Access Compliance Report Public Rights-of-Way (Curb Ramps)

Main Street: SADDLERY_RD Cross Street: LEMON_HEIGHTS_DR Location: E

ADA ID: RPRK211014110353 Ramp Type: Type 6 - Directional 1 Initial Pass/Fail: Pass Overall Compliance: No Severity Score: 35

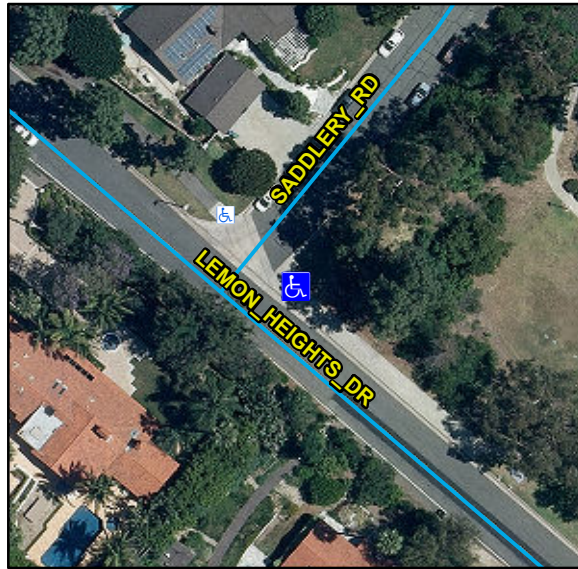
Compliance	Description	Data	Compliance	Description	Data
N/A	Ramp Length (in)	90	Yes	Flare Type LT	
Yes	Ramp Width (in)	70			Curbed2
Yes	Ramp Run Slope (%)	1.9	N/A	Flare Slope LT (%)	N/A
No	Ramp Cross Slope (%)	5.8	N/A	Flare Traversable LT	N/A
No	Grade Break	No	N/A	Flare Type RT	
N/A	Grade Break Slope (%)	N/A			Sloped
N/A	Grade Break Cross Slope (%)	N/A	Yes	Flare Slope RT (%)	0.6
	Addl Para Ramp Left?	No	N/A	Flare Traversable RT	Yes
	Addl Para Ramp Right?	No	No	DWS Provided	No
N/A	Landing Present	Yes	N/A	DWS Contrast	N/A
Yes	Landing Length (in)	136	N/A	DWS Length (in)	N/A
Yes	Landing Width (in)	108	N/A	DWS Full Width	N/A
No	Landing Run Slope (%)	10		DWS Offset Type	N/A
Yes	Landing Cross Slope (%)	2.7	N/A	DWS Left Offset (in)	N/A
N/A	Landing Movement Obstructed?	No	N/A	DWS Right Offset (in)	N/A
	Landing Movement Type	N/A			
N/A	Landing Shared	No			
N/A	Marked Crosswalk 1	No	N/A	Clear Space	N/A
	Crossing 1 Direction	NW	N/A	Clear Space To Crosswalk (in)	N/A

N/A	Marked Crosswalk 1 Width (in)	N/A			
N/A	Ramp Inside Crosswalk 1	N/A			
	Crossing 1 Slope (%)	5.1			
	Crossing 1 Cross Slope (%)	7.4			
Yes	Gutter Ponding	No	N/A	Curb Slope	6.7
Yes	Gutter Lip Height (in)	0		Road Run Slope (%)	N/A
No	Gutter Run Slope (%)	14.6		Road Cross Slope (%)	N/A
No	Gutter Cross Slope (%)	9.8		Parallel Ramp Side	Left
Yes	Overall Surface Condition	Acceptable	Yes	Perp Joint Present	Yes
	Cross Gutter Present?	Yes		Spandrel Present?	Yes
	Replace Cross Gutter?	No		Replace Spandrel?	No

Remove & Replace Entire Ramp. Remove & Replace Gutter.
